UN#10-122

**Response to NRC RAI No. 101
Questions 02.04.12-9, 02.04.12-10 and 02.04.12-11,**

Calvert Cliffs Nuclear Power Plant Unit 3

**Update of COLA Part 2, FSAR
to incorporate the new Groundwater Model**

Figure 2.4-97—{Modeled Post-Construction Depth to the Surficial Aquifer Water Table in the Unit 3 Power Block Area}

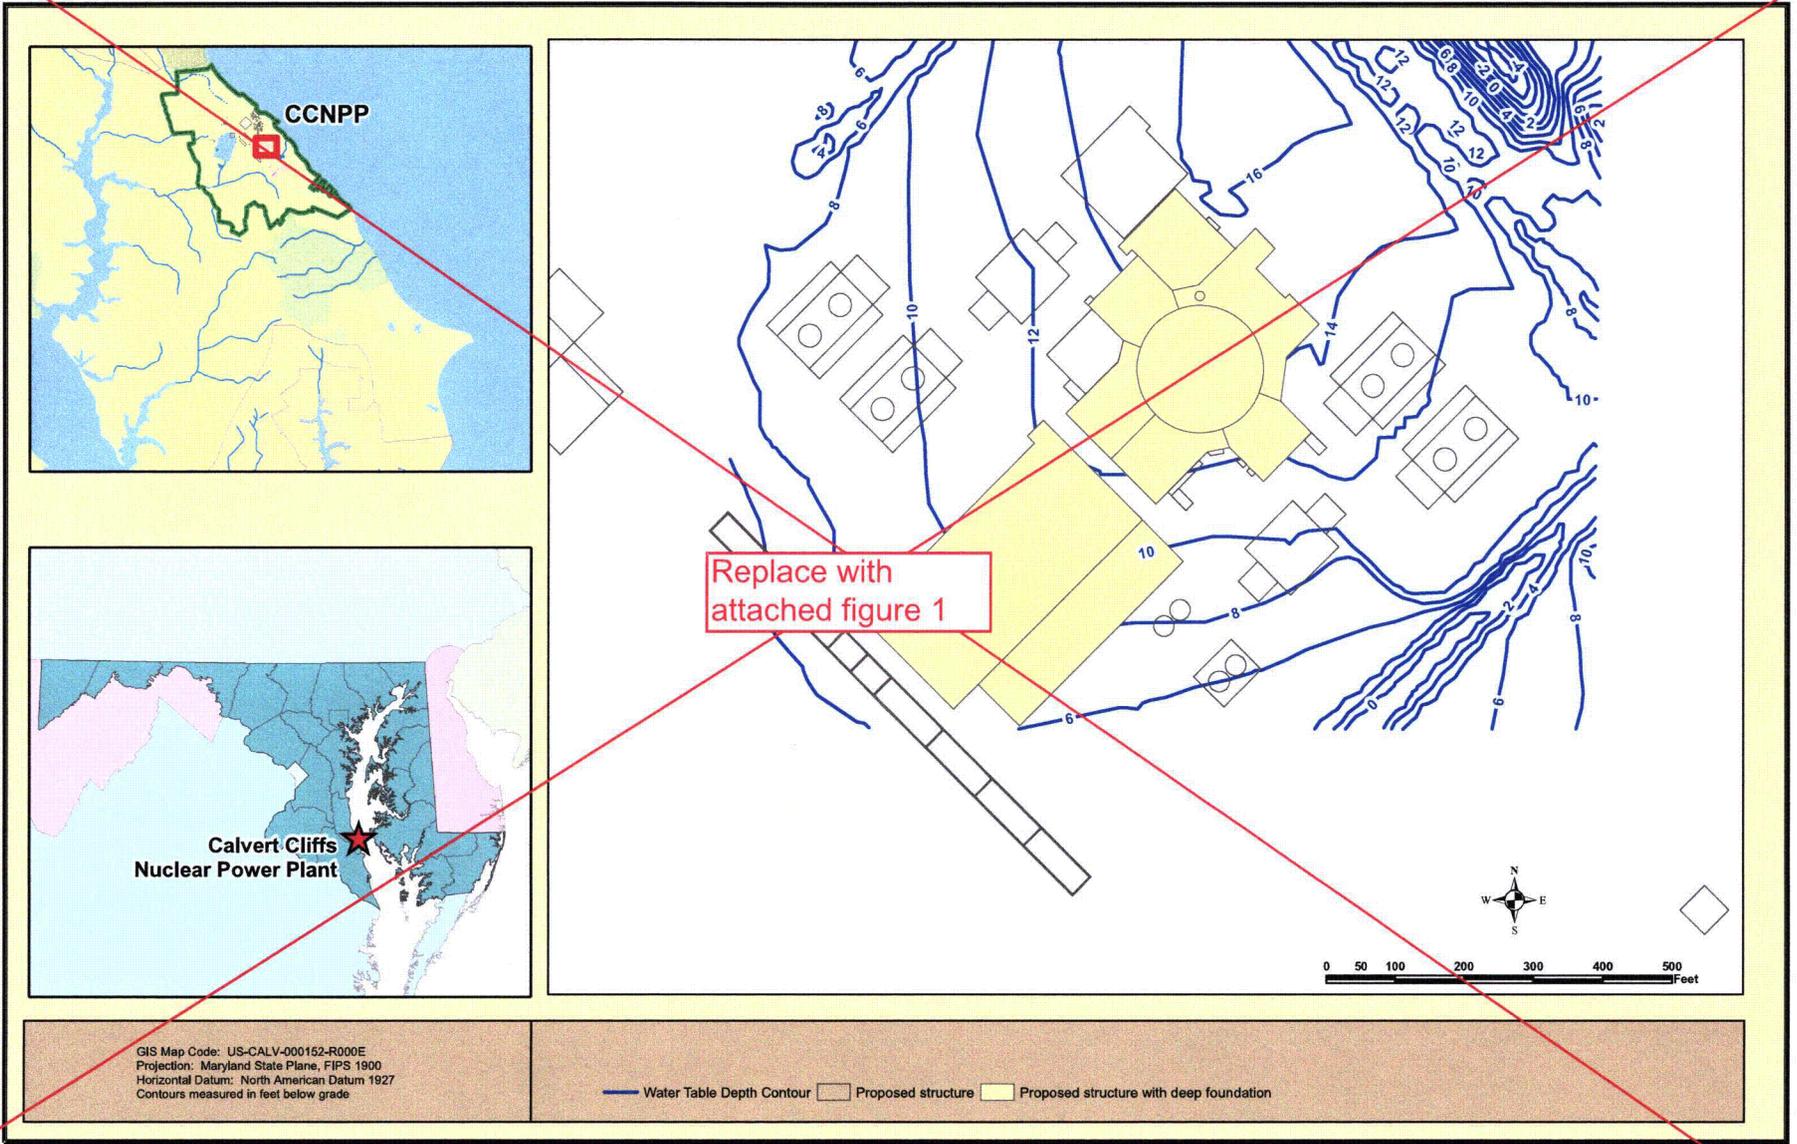
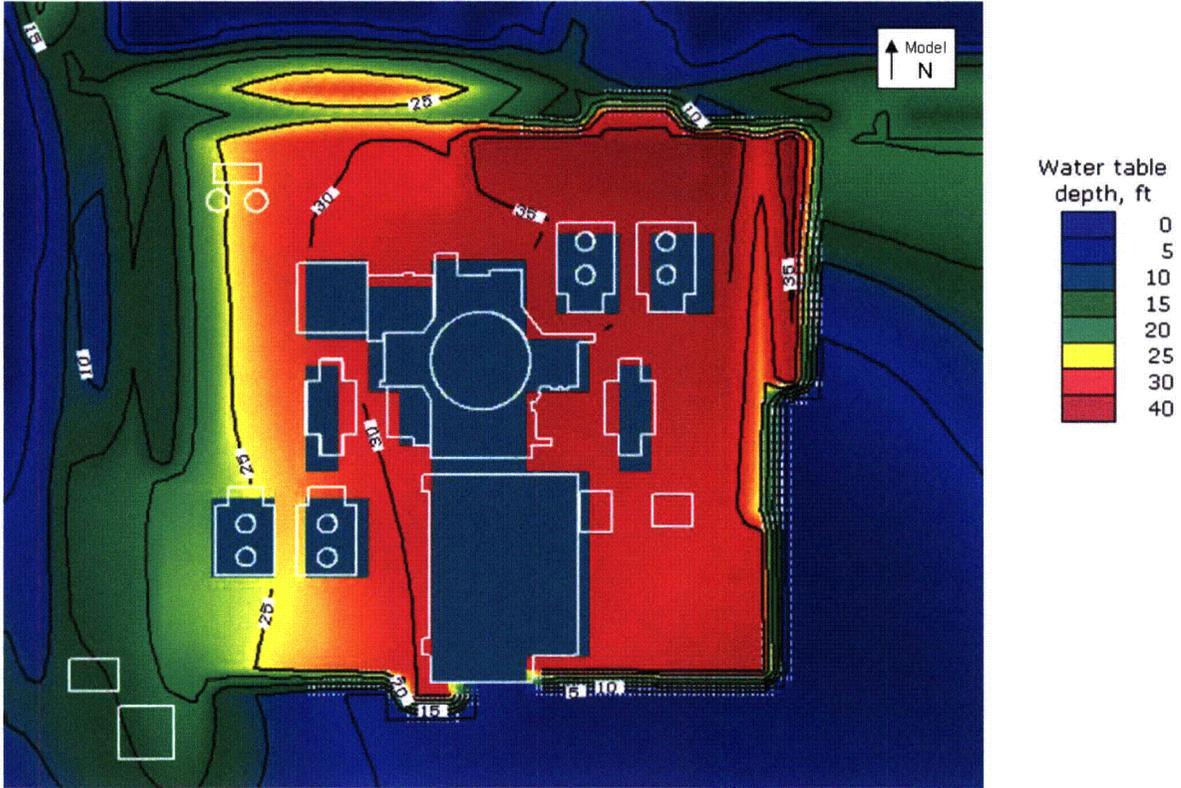
Replace with attached figure 1

Replacement FSAR Figure 2.4-97

Figure 2.4-98—{Modeled Post-Construction Elevation of the ~~Surficial Aquifer~~ Water Table in the Unit 3 Power Block Area}

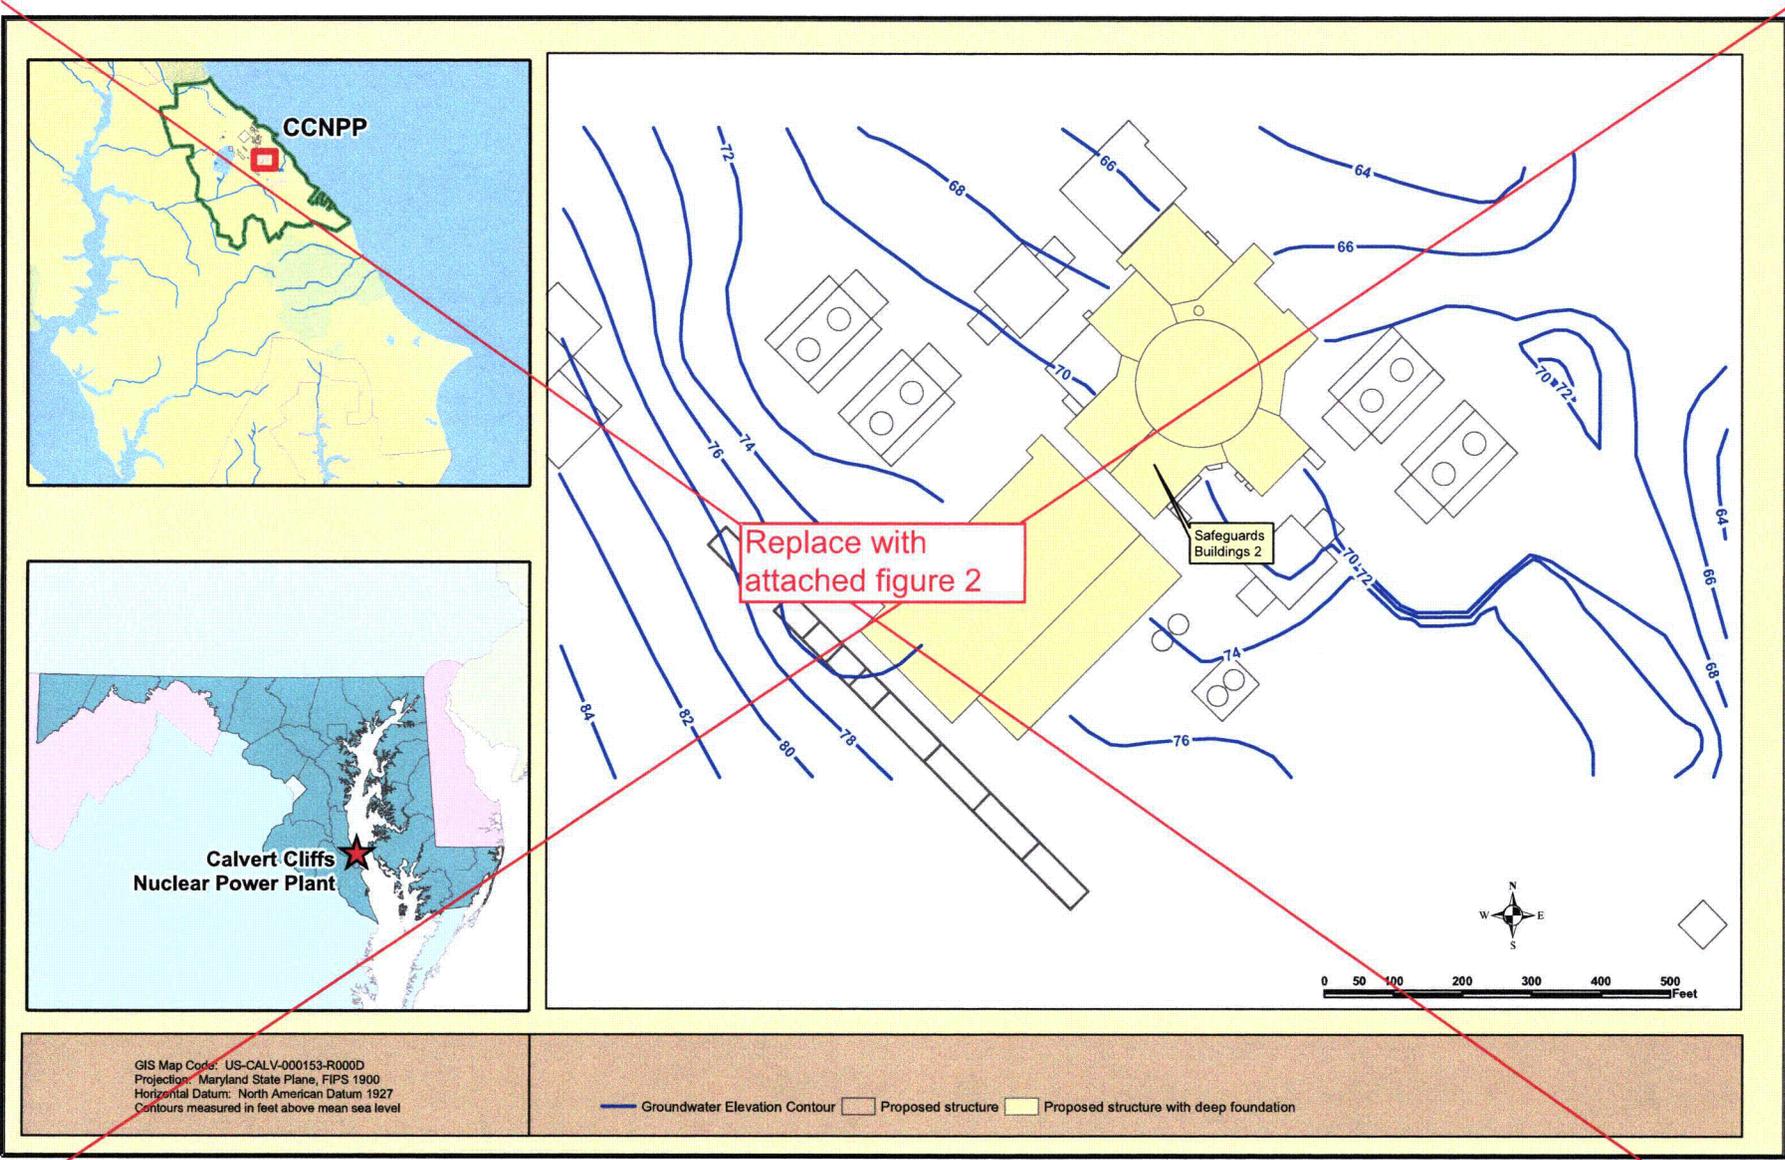
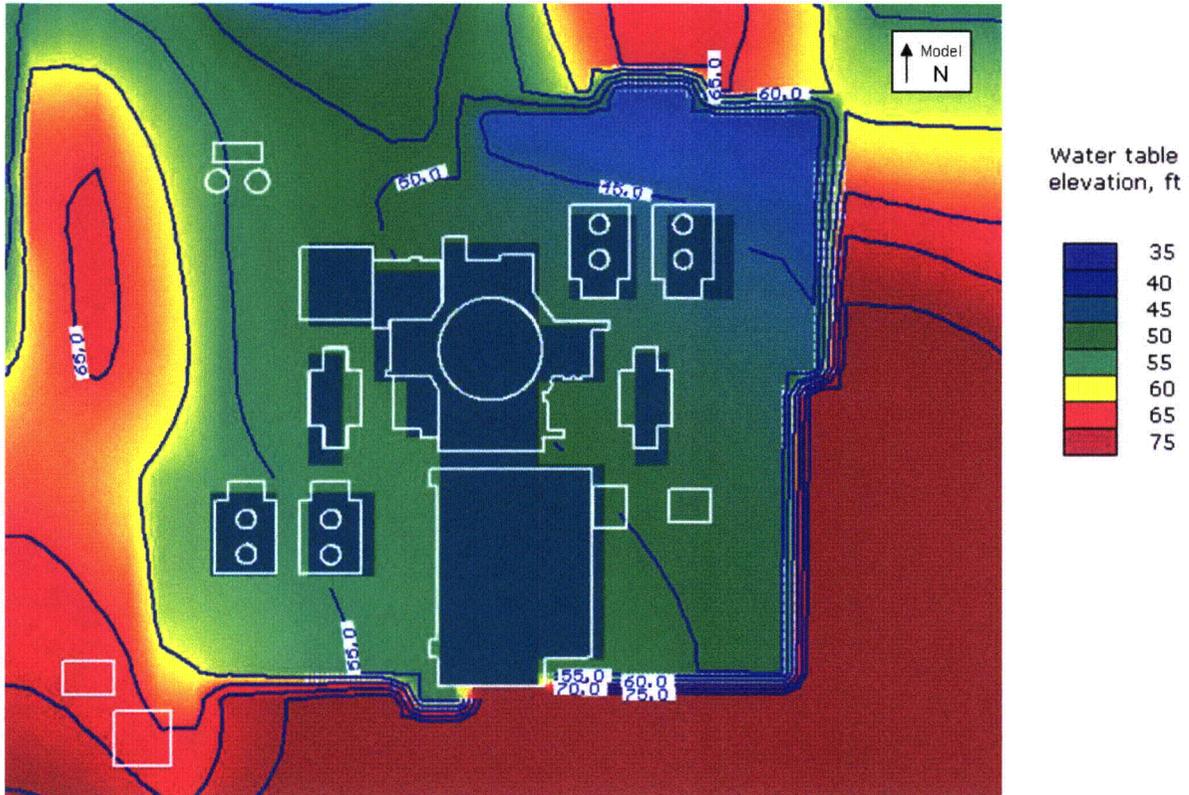
Figure 2
Replacement Figure 2.4-98

Figure 2.4-107—{Topography of the Post-Construction Groundwater Flow Model Domain}

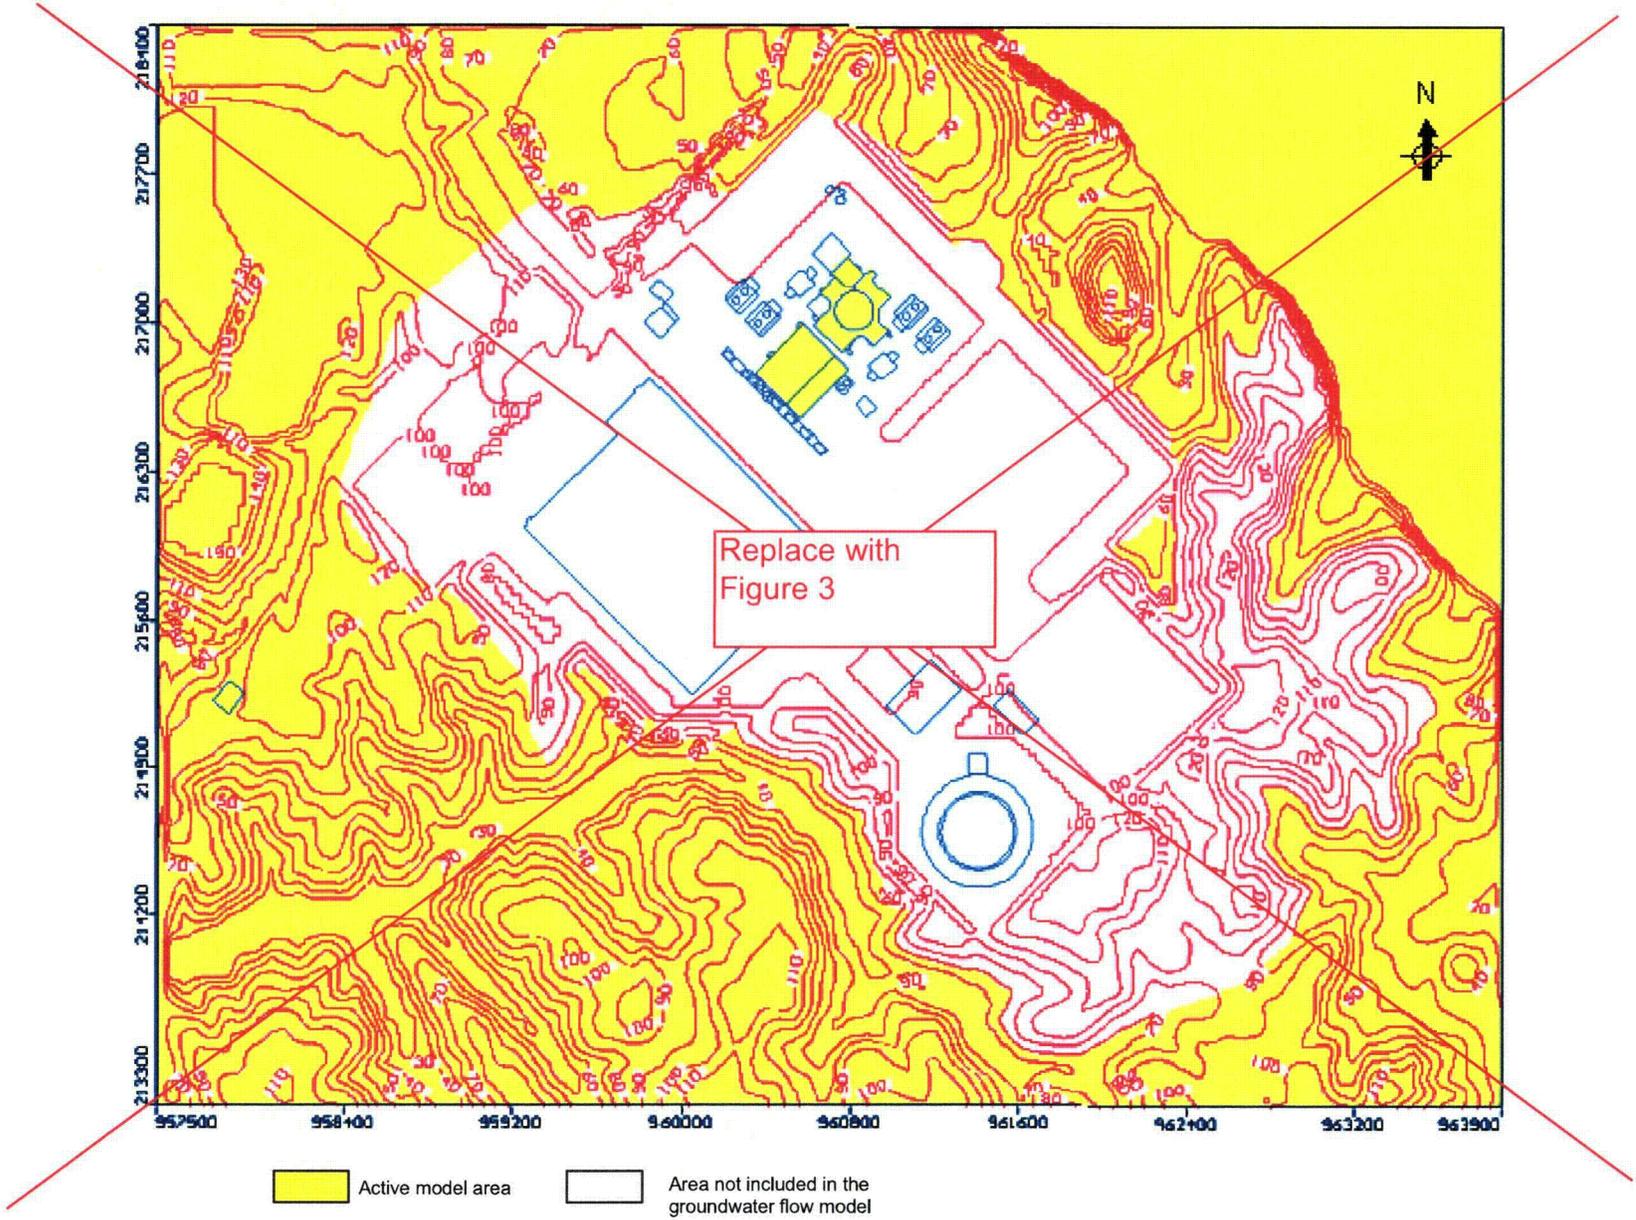
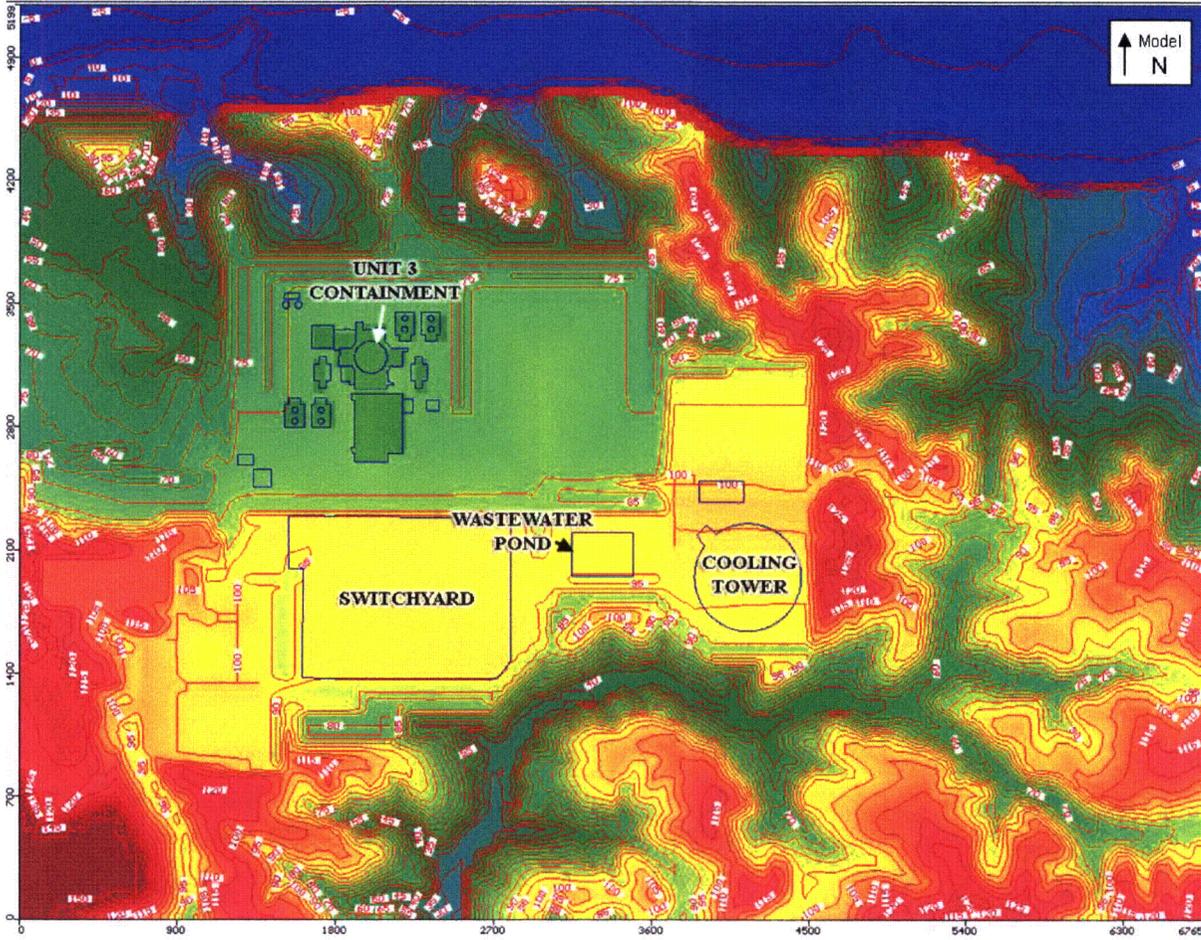
Replacement Figure 2.4-107

Figure 2.3-79—Modeled Post-Construction Depth to Surficial Aquifer Water Table Around Power Block 3

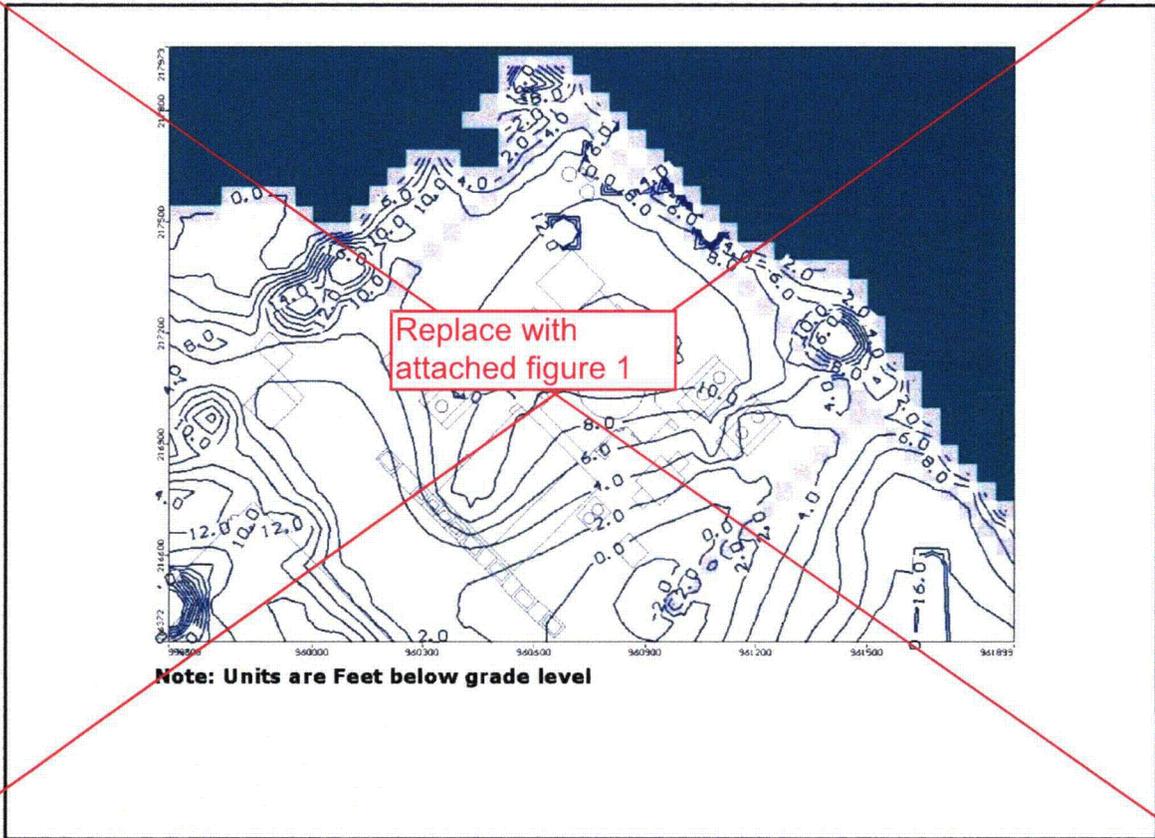
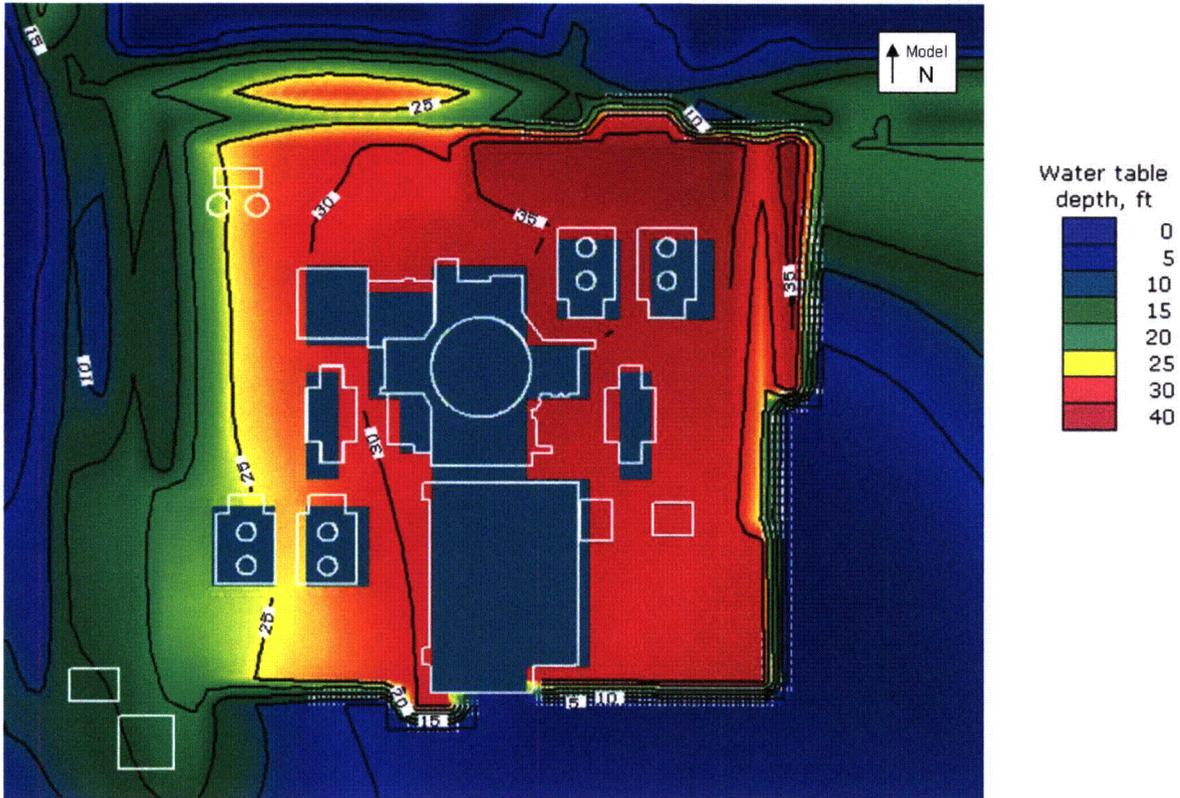
Replacement ER Figure 2.3-79
